Subject: Revised Responses to US-APWR DCD RAI No.744-5668 Revision 2 (SRP 19.0)

Revised Responses to Request for Additional Information
No.744-5668
Revision 2

US-APWR Design Certification

RAI NO.: NO. 744-5668 REVISION 2
SRP SECTION: 19 – Probabilistic Risk Assessment and Severe Accident Evaluation
APPLICATION SECTION: 19.1
DATE OF RAI ISSUE: 04/27/2011

Figure 1 Revised MCR Event Tree

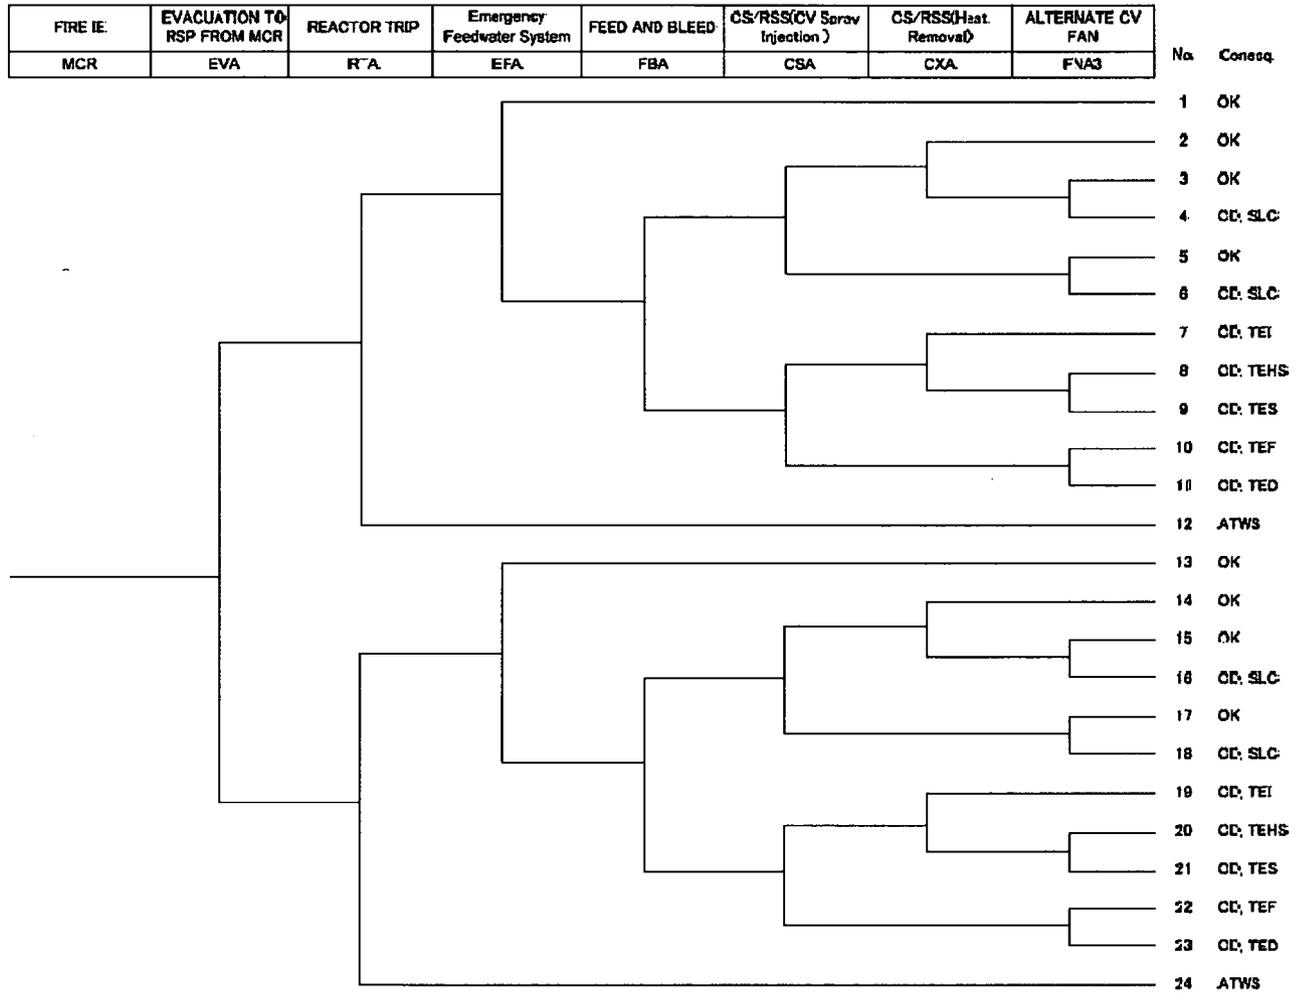
(Follow-up to Question 19-462) Please (a) describe in more detail and provide the failure probability of top event "EVA - Evacuation to RSP from MCR," (b) provide the accident frequencies of main control room sequences shown in Figure 1, and (c) explain why both success and failure paths of top event EVA are identical.

(b) Accident frequencies of main control room sequences shown in Figure 1

Each sequence of the MCR event tree in Figure-1 is as follows. The accident frequencies are results from the internal fire PRA in DCD Revision 3. The fire PRA model is updated according to the internal event PRA model.

Accident Sequence Number of MCR-ET	CDF(/RY)
4	3.8E-13
6	5.5E-12
7	3.4E-10
8	2.7E-14
9	3.9E-15
10	9.9E-13
11	4.2E-12
16	7.8E-13
18	5.0E-12
19	8.1E-09
20	6.8E-13
21	1.1E-13
22	1.1E-11
23	8.5E-12

(c) Reason why both success and failure paths of top event EVA are identical

Figure 1 MCR event tree has been developed to quantify sequences for both operations at the MCR and at the RSC. The sequences of the event tree after the upper branch of top event "EVA" are for the MCR and the sequences after the lower branch of "EVA" are for the RSC. The success and failure paths of top event EVA are identical because the RSC has the same functions and capabilities for the safety VDUs at the operator console (OC) in the MCR, and all equipment that is operated from the safety VDU of the OC in the MCR can be operated from the RSC.

Although the same operation could be taken by the operators in the MCR and in the RSC, each human error probability of the operation from the safety VDU in the MCR and in the RSC is different. Because Bypassed or Inoperable Status Indication (BISI) information is displayed on the Large Display Panel (LDP) in the MCR as an alarm, operators in MCR could easily recognize the plant abnormal condition and share the information. Additionally, because Supervisor Console and Shift Technical Advisor Console are also installed in MCR, senior reactor operators (SRO) could easily

hold the plant condition and actions by other reactor operator. However, it is more difficult for operators to recognize plant abnormal condition and to achieve recovery action by SRO in RSC room than in MCR because LDP or associated consoles are not installed in RSC room. Therefore, it is assumed that HEP of the operation in RSC room is higher than that in MCR. The human error of 0.1 is assumed to the operations from RSC that covers alternate shutdown means.
